SERVICE No.235 BULLETIN

Piper Aircraft Corporation

September 16, 1966

Standardization of Never-To-Exceed Airspeed Limit

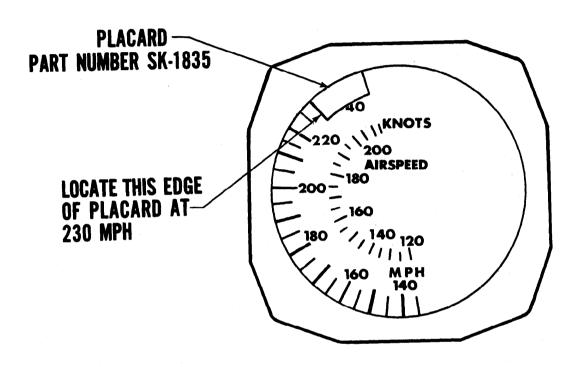
The installation of various optional equipment and S.T.C. approvals in the above referenced basic aircraft has made it desirable to standardize the never-to-exceed airspeed limit. The new never-to-exceed airspeed limit is 230 MPH.

A placard for the airspeed indicator, part number SK-1835, and a revised Flight Manual, Piper Report No. 1269 dated August 31, 1966 reflecting this change are available through your Piper distributor.

Information concerning the installation of the airspeed placard is contained on the sketch on the reverse side of this bulletin.

The airspeed indicator placard, part number SK-1835, is not required on aircraft equipped with Brittain Industries tip tanks Model No. TT-5 since these aircraft are already restricted to a 230 MPH never-to-exceed airspeed limit. However, the revised Flight Manual, Piper Report No. 1269 dated August 31, 1966 reflecting the never-to-exceed airspeed limit change is required.
